UVAR SAFETY ANALYSIS REPORT

PROPOSED AMENDMENT

SAFETY ANALYSIS REPORT
FOR THE
LOW-ENRICHED URANIUM FUELED
UNIVERSITY OF VIRGINIA REACTOR

Figure 4.1 Cooling System Flow Diagram
(REVISED 10/95)

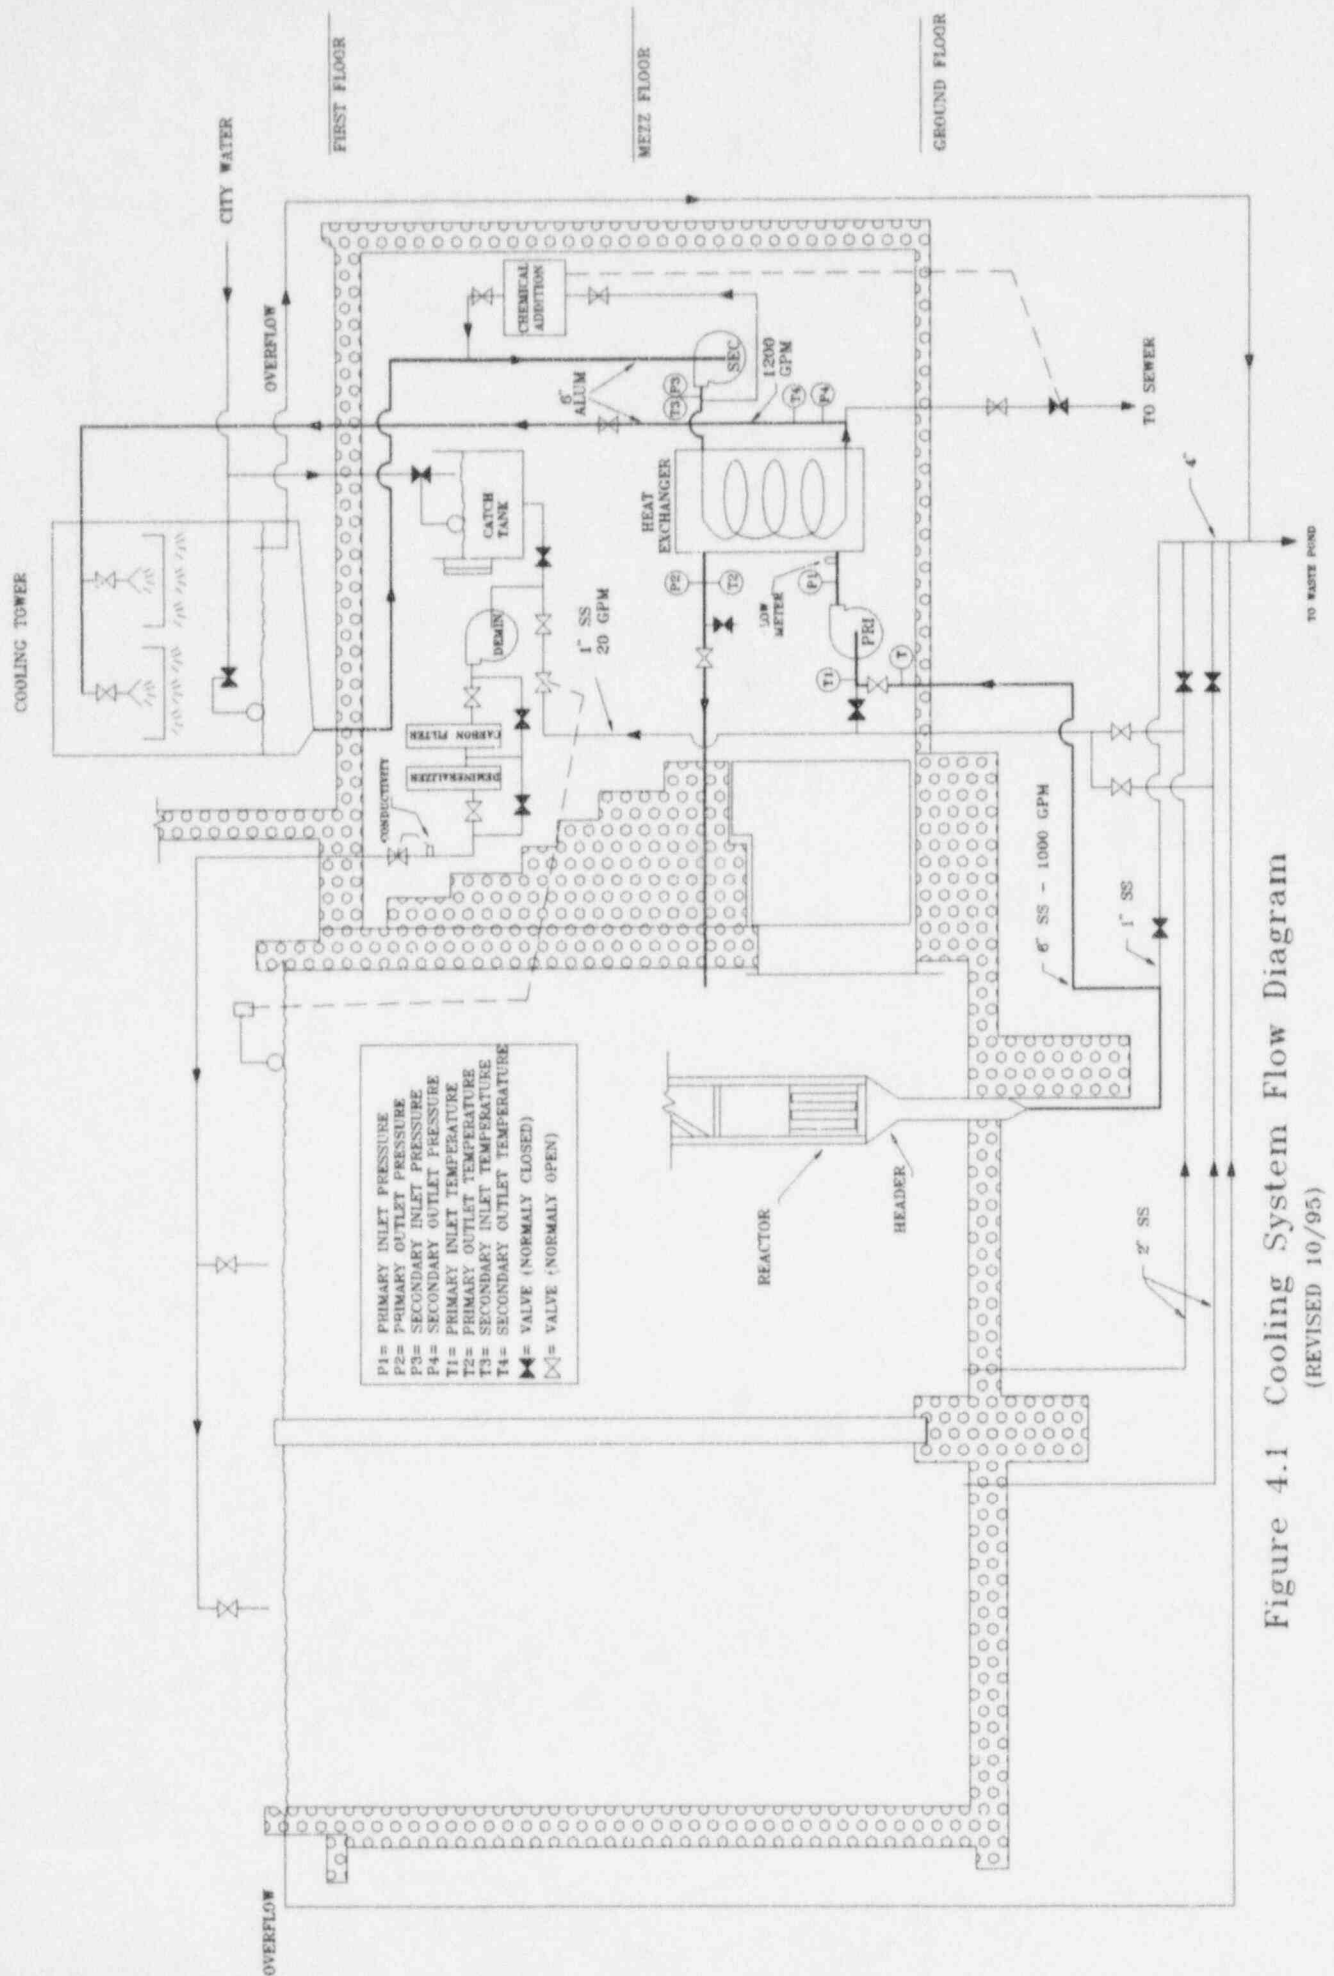
4.6.1 Replacement of Heat Exchanger System Components

When a heat exchanger system component, e.g., primary pump, secondary pump, heat exchanger, secondary tube plug, cooling tower, associated piping and valves, is to be replaced, a Title 10 Code of Federal Regulations 50.59 analysis shall be performed to determine suitability of the replacement equipment. Because only a limited number of system specifications are critical, most components can be replaced with a fairly wide range of substitutes. Consideration must always be given to material compatibility. For example, wetted parts of pumps must be aluminum-compatible. Also, care must be taken to maintain the required primary coolant flow rate. Finally, replacement components should be able to withstand the system pressures, with reasonably large excess margins.

It is unlikely that exact replacements of system components several decades old can be located. In the cases of the heat exchanger and cooling tower, the replacement component is likely to be of a different style, design, or type from the original. Such differences are acceptable once a "10 CFR 50.59 analysis" finds that the replacement is capable of performing its intended function. With that qualification, heat

exchanger system component changes do not pose "unreviewed safety questions".

Changes of these components are permissible once a 10 CFR 50.59 analysis performed by the Reactor Staff is reviewed and approved by the Reactor Safety Committee.

TABLE 4.1.A Heat Exchanger Secondary Tube Plug Specification

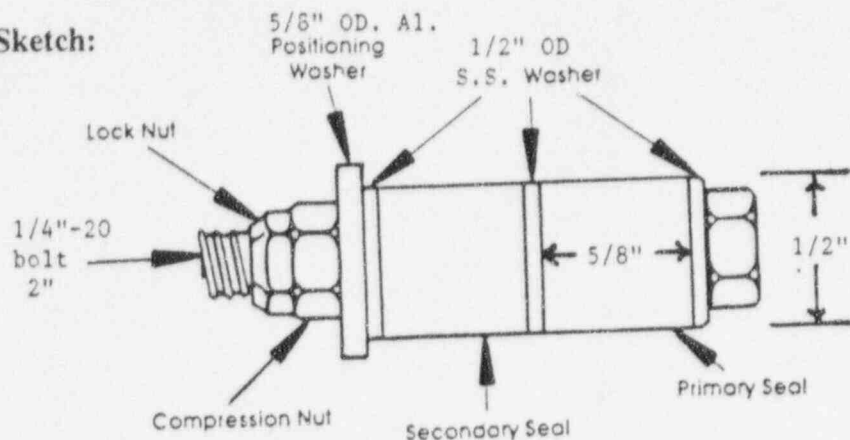
When heat exchanger secondary tubes are found to leak, they may be plugged with the type of replaceable expansion plug specified in TABLE 4.1.A. Tubes may be plugged up to a maximum number at which the heat exchanger secondary maximum working pressure is reached, as specified in TABLE 4.1. These pressures shall be monitored with heat exchanger inlet and outlet pressure gauges shown in Figure 4.1, following plug insertion. Secondary pump operating specifications, in TABLE 4.3, should also be consulted to set a reasonable lower limit on minimum steady-state flow through this pump.

Secondary tube plug installation does not affect primary coolant flow. This is because primary flow in the heat exchanger is through the shell side. The heat transfer rate is not of safety consideration. Reduction of cooling capacity resulting from tube plugging may affect the length of time the UVAR is operated on hot summer days until maximum pool water temperature (scram set-point at 105 Deg. F.) is reached.

Screw, nuts, and interior washers may be stainless steel or aluminum.

Retaining washer must be aluminum. No dissimilar metal shall be in contact with the heat exchanger tubes.

Expandable/Compressible Tubing Material: Norprene or equivalent rubber.

Shaft (Screw): 1 pcs., 1/4"-20 by 2".

Nuts: 2 pcs., 1/4"-20, 1 locking, 1 normal.

Washer 1: 3 pcs., 1/2 O.D., stainless steel between seals.

Washer 2: 1 pcs., 5/8" O.D., aluminum only, plug positioning washer

Installation: against tube sheet support only.

Maximum Number to be Installed: To be determined, based upon allowable heat exchanger secondary-side working pressure, and secondary pump flow.

Testing and final installation torque: 12 inch-pounds.

Test Pressure: 150 psi (checked in a bench-rig).

Surveillance interval: annual, with removal and inspection of one plug from longest-installed group of plugs.
